# Work Order ID 121411

Item Name: Quick Release Basket Mounting Spacepod™ & Squirrel Cheek Fits LH or RH

**DART SERVICE INSTRUCTION**

TO AMEND INSTALLATION INSTRUCTIONS D350-607-3 Rev.D,  
 INSTALLATION INSTRUCTIONS D350-607-4 Rev. C AND  
 INSTRUCTIONS FOR CONTINUED AIRWORTHINESS ICA-D350-607 REV. 6  
 REF TCCA STC: SH94-14  
 REF FAA STC: SR00213NY  
 REF EASA STC: EASA.10016996  
 REF BRAZILIAN STC: 2007S03-03/-04/-05/-06

**FIGURE 1: INSTALLATION OF D4775-041 FWD STRUT**

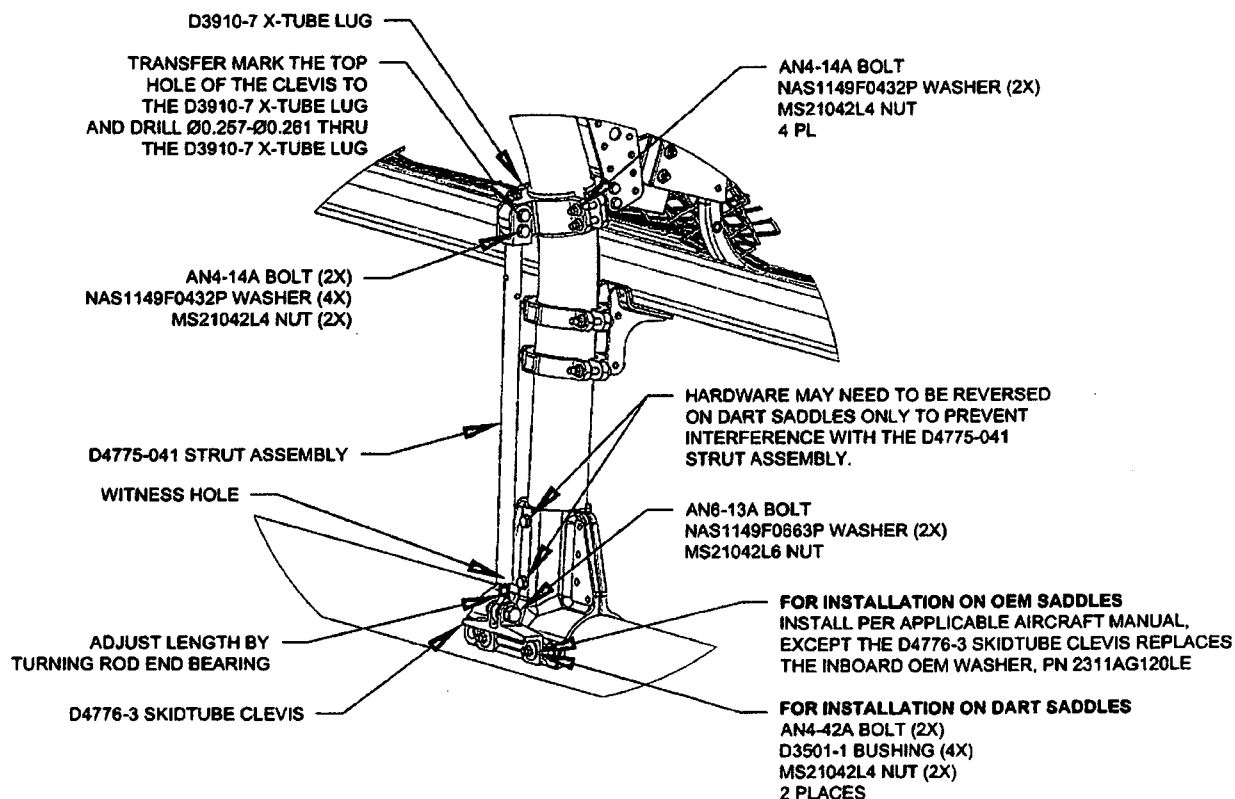
3.1 Substitute the Forward Lower D3910-5 X-Tube Lug with the D3910-7 X-Tube Lug as shown in Figure 1.

3.2 Install the forward D4775-041 Strut Assembly. Transfer mark from the upper hole on the clevis of the D4775-041 Strut Assembly to the D3910-7 X-tube Lug and drill thru the lug  $\varnothing 0.257$ - $\varnothing 0.261$  as shown in Figure 1. Touch up chemical conversion coating per MIL-DTL-5541. Check the witness holes located at the bottom end of the D4775-041 Strut Assemblies to ensure that the thread from the rod end extends past the witness hole.  
**Torque MS21042L4/-4 nuts to 50-70 in-lbs (5.7-7.9 N-m). Torque MS21042L6/-6 nuts to 160-190 in-lbs (18.1-21.5 N-m).**
